**HI-STORE Consolidated Interim Storage Facility
Requests for Additional Information Round 2
Attachment 2 Holtec Letter 5025068**

CHAPTER 2 RAIs

Figure 2 West Egg Roll Development Area [3]

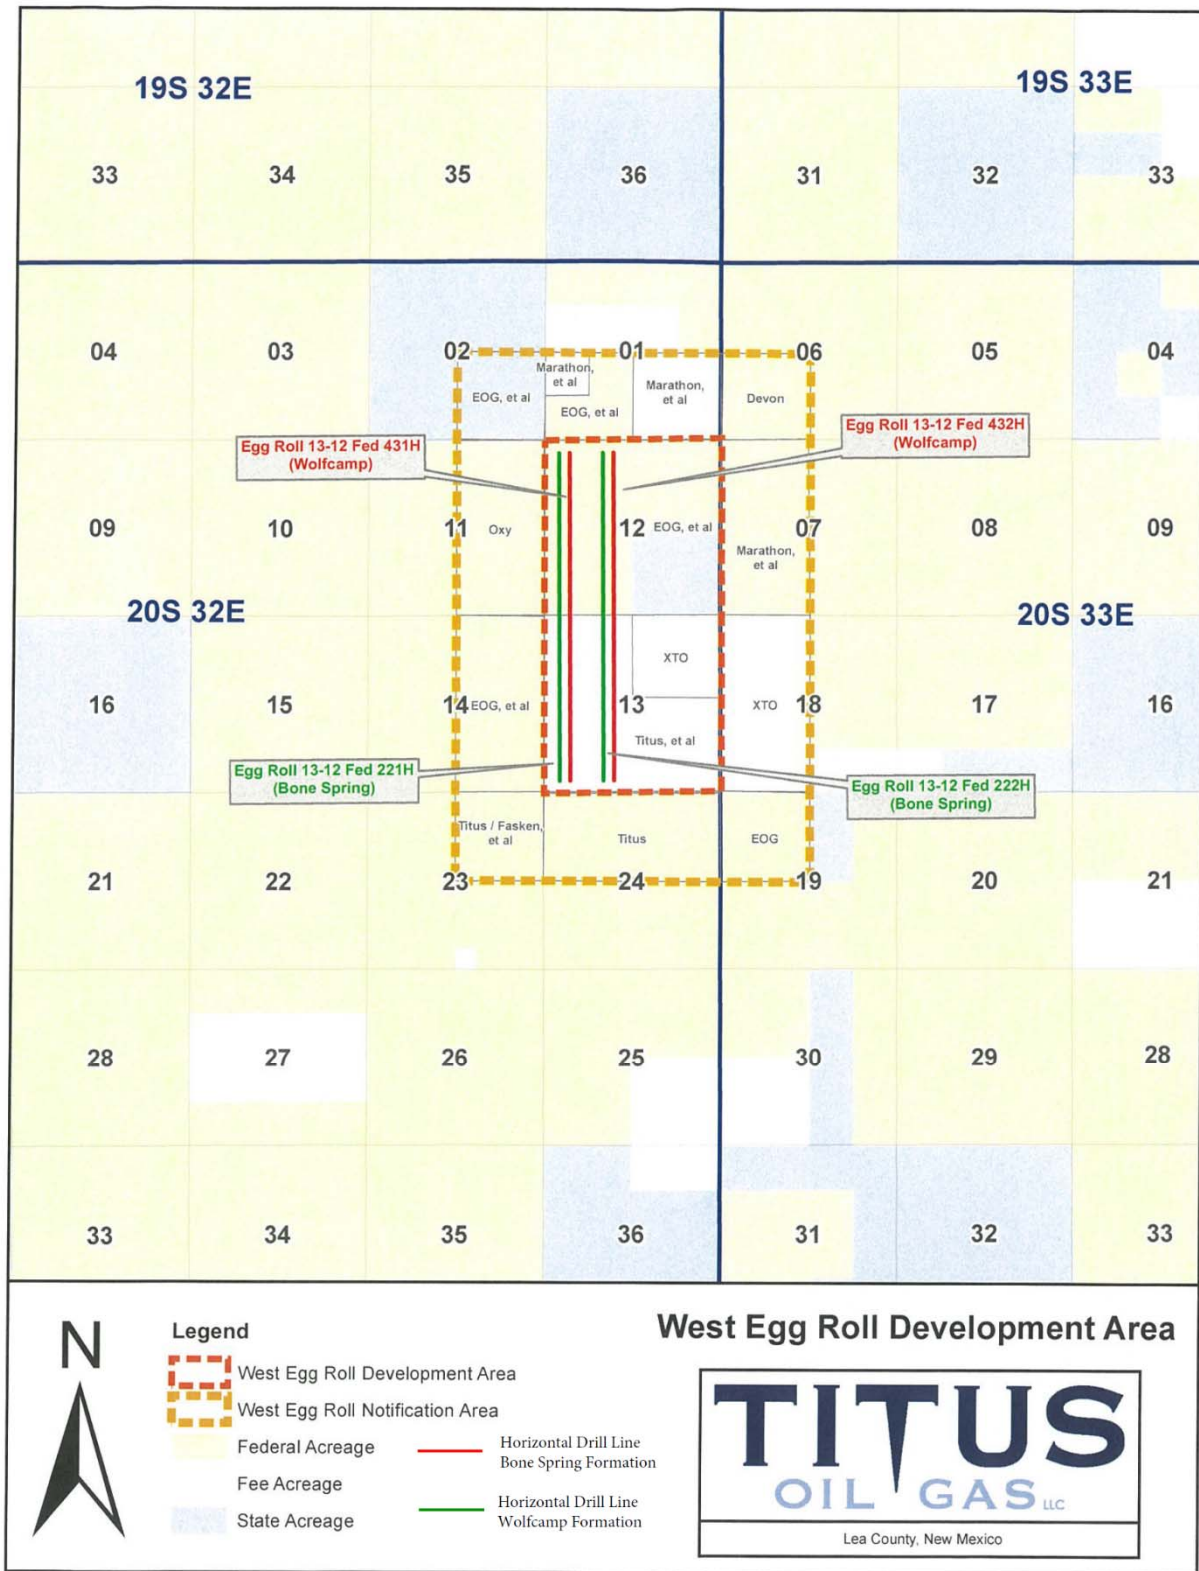
RAI 2-8-S: Provide the basis for the statement in the response to RAI 2-8 that, *“[n]o new oil and gas wells will be constructed within the Facility boundaries because new drill islands will not be permitted on the privately owned land.”*

The response to RAI 2-8 does not provide a discussion or justification for why new drill islands would not be permitted within the privately owned land where the facility will be constructed.

The HI-STORE facility is proposed to be built on Section 13 of Township 20 South, Range 32 East, N.M.P.M. which is State Land within the SOI PA. Section 13 is part of Development Area (DA) “West Egg Roll” as defined by Titus Oil and Gas LLC (Titus) [3], Figure 2. Under SOI Order 3324, a Development Area is:

In the case of the proposed Holtec facility, the oil and gas beneath Section 13 is already available for access through the Tetris Anise DI immediately south of Section 13. Indeed, that DI was located there specifically for the purpose of accessing the minerals beneath Section 13 [4]. Thus, with access to those resources already secured and available, it appears that additional drilling directly on Section 13 would likely amount to unreasonable or excessive use of the surface lands, potentially allowing for litigation from the surface owner with potential damages for the oil and gas lessee.

Figure 2 Potash Rights, Oil and Gas Buffers, and Mine Workings

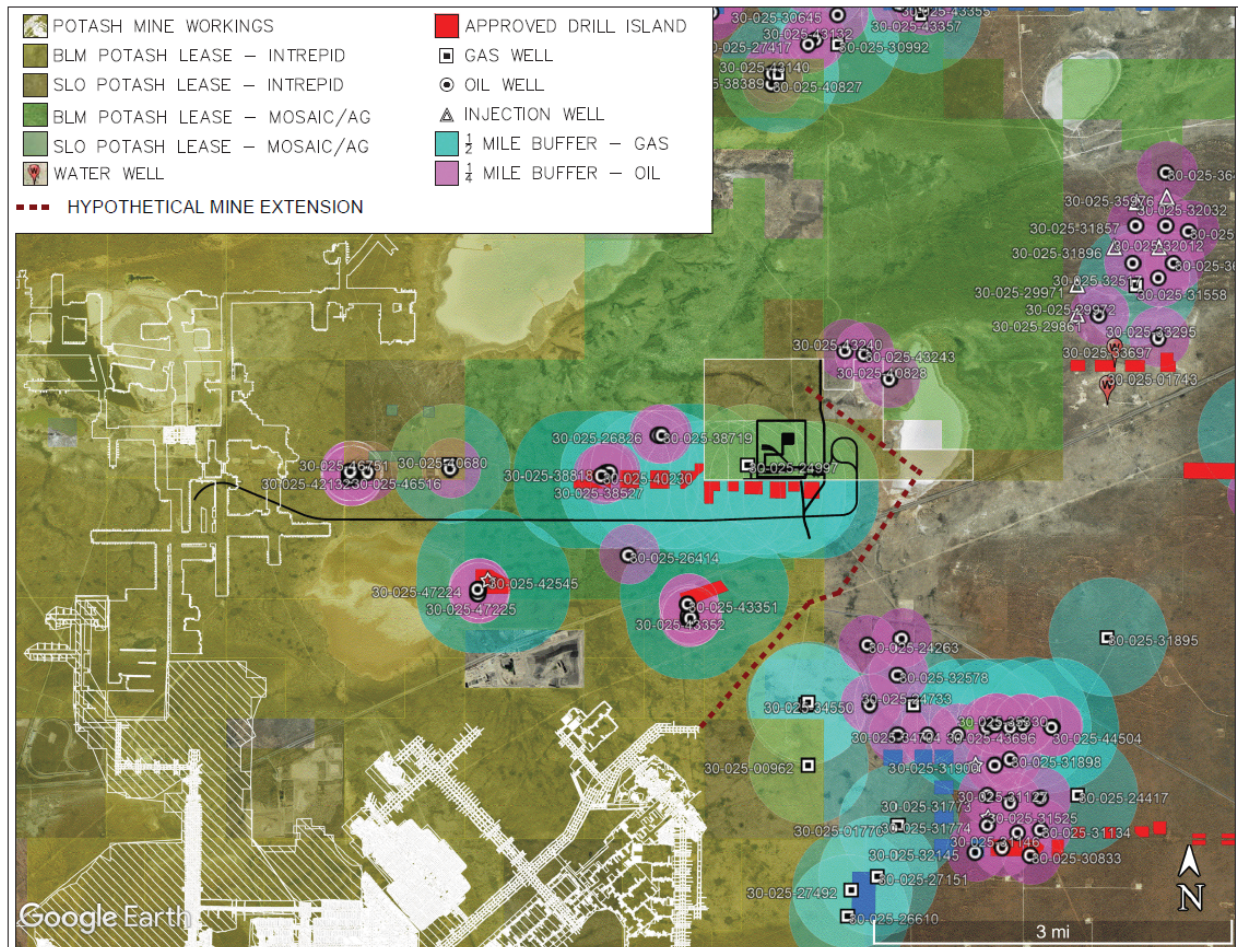
RAI 2-12-S: Provide a legend for Figure 1 to the response to RAI 2-12 (Figure 2.1.24 in HISTORE SAR, Rev. M) for each color and size of circles and squares depicted. Also, provide a detailed discussion as to why mining of potash would not be feasible beneath or around the proposed CISF site for the proposed duration of the license.

Both SAR Figure 2.1.24 and Figure 1 of the RAI response do not have any description of the colors and symbols used to depict features. Additionally, explain in detail the basis for the conclusion that mining of potash from underneath the proposed CISF site would not be feasible for the proposed duration of the license. For example, explain the extent to which this position relies on the State of New Mexico, Oil Conservation Commission's Order No. R-111-P, or the U.S. Secretary of the Interior Order No. 3324.

In the implementation of SOI Orders 3324 and EMNRD OCC R-111-P, the Bureau of Land Management and EMNRD OCC coordinate potash, oil, and gas harvesting with local lease holders. Figure 1 shows the complexity of ongoing operations in the vicinity of the proposed facility based on the mining buffer zones required by the orders. Mining around and under the proposed facility can only be done by extending current mine workings or creating a new mineshaft.

Intrepid has the only available approach from existing mine workings (Figure 1). Mining would be required to proceed north from the existing mine workings, between the buffer zones for the “Snoddy Federal #021H” (API 30-025-40838) well and the “Felmont Federal Com #002” (API 30-025-26302) well. This pathway is less than 1000 ft wide. Once clear of these wells, the new mine workings would have to continue north, passing under Laguna Gatuna and into the Intrepid owned mineral rights in Section 13. The total extension of the existing mine workings would be over 3 miles.

Figure 2-19_1: Maximum vs Allowable Velocity

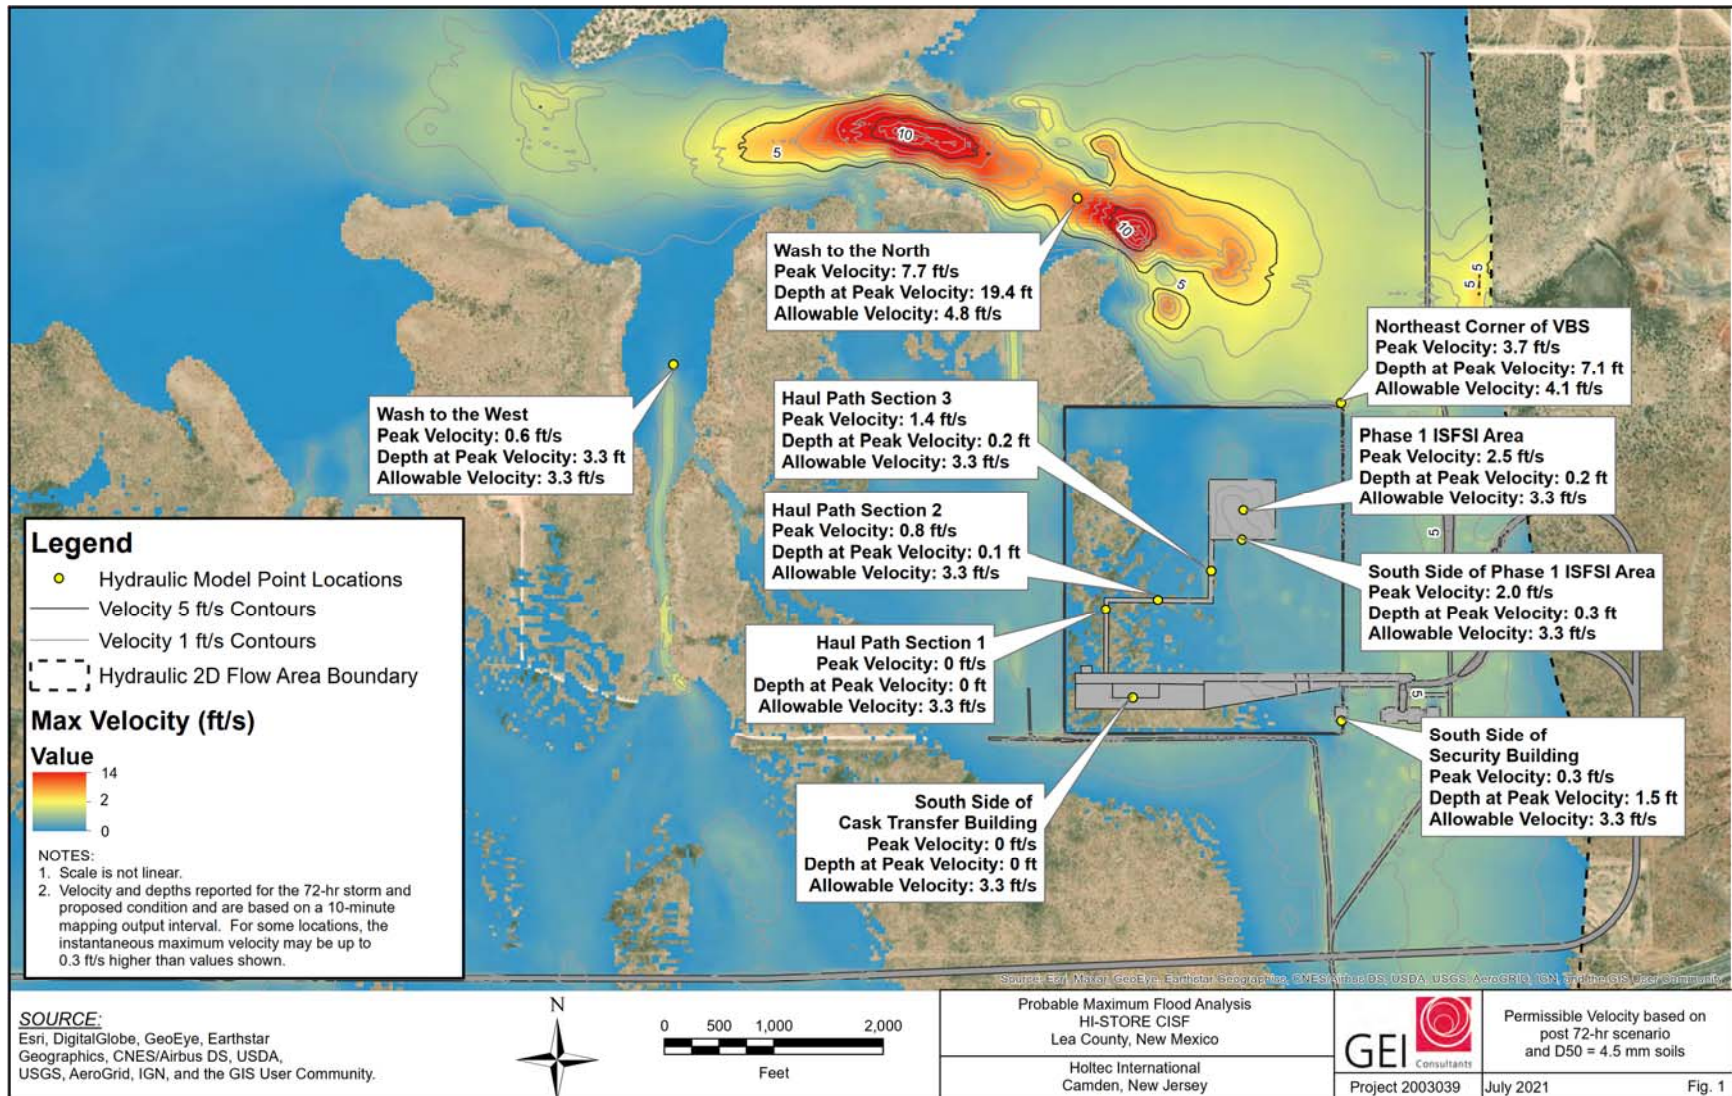
RAI 2-19-S: Provide additional information to justify that on-site flooding due to PMP storm events will not cause damage to important to safety (ITS) structures, systems, and components (SSCs) at the HI-STORE CISF site.

flooding analysis, which demonstrates that a canister would not leak in evaluated flooding conditions, the SAR should discuss what effects, if any, the onsite flood water depth would have on the UMAX pad system, including the backfill, cementitious material between casks and around casks. This should include water depth from surface water ponding and a column of saturated subsurface soil with groundwater, including the loading from the saturated backfill material. Furthermore, based on hydraulic modeling results, the applicant should provide a map of the CISF clarifying where soil erosion may occur and its impact, if any, on ITS SSCs or physical security structures. The applicant should describe mitigation actions it plans to take in the event soil erosion does happen.

Regarding potential soil erosion at the facility during the PMP/PMF event, the Figure 2-19-1 below maps the peak PMF velocities across the facility and provides specific information for key locations on site. In addition to the peak velocity at the key locations, the figure provides the corresponding flood depth and a threshold/permissible velocity above which erosion would be expected.

As can be seen in Figure 2-19-1, the peak PMF velocity at all of the onsite facility components (Security Building, Cask Transfer Building, Haul Path, ISFSI, or Fences) does not exceed the allowable velocity. Therefore, the potential for erosion adjacent to these features is very low, and any erosion that may occur would be minimal and have no effect on the structures.

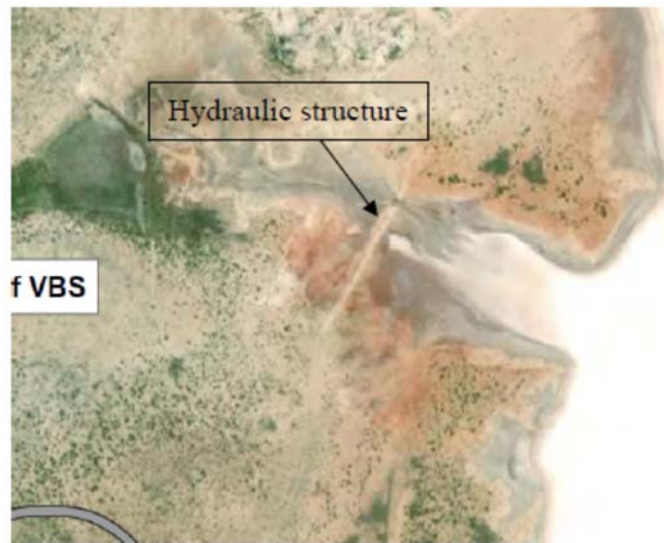
RAI 2-20-S: Provide an estimate of the likelihood that flooding may occur from a 100-year storm event as a result of damage to the hydraulic structure near Laguna Gatuna.

In its response to RAI 2-20, the applicant provided a PMP/PMF study (GEI, 2019), which assumes Laguna Gatuna in ‘extreme full’ condition, with water inundating the hydraulic structure. The effect of the hydraulic structure on flooding is thus accounted for. However, in the 100-yr storm event, where the Laguna was assumed to be filled with 5 feet deep of water, runoff into the wash and the hydraulic structure (looking like an earthen dam with an area that has been broken – see picture taken from the GEI report, Fig. 6) may create back water effect, which in turn may cause flooding around the northeastern corner of the proposed CISF. Provide calculations to estimate the likelihood that flooding may occur and, if so, at what depth under this scenario.

Alternatively, most of the water in Laguna Gatuna will be stored east of this structure in a sub- PMP storm event. Provide additional analyses to determine the potential impact of the structure’s partial or complete collapse (e.g., the potential for flooding to the wash northeast of the proposed CISF), particularly under sub-PMP weather conditions.
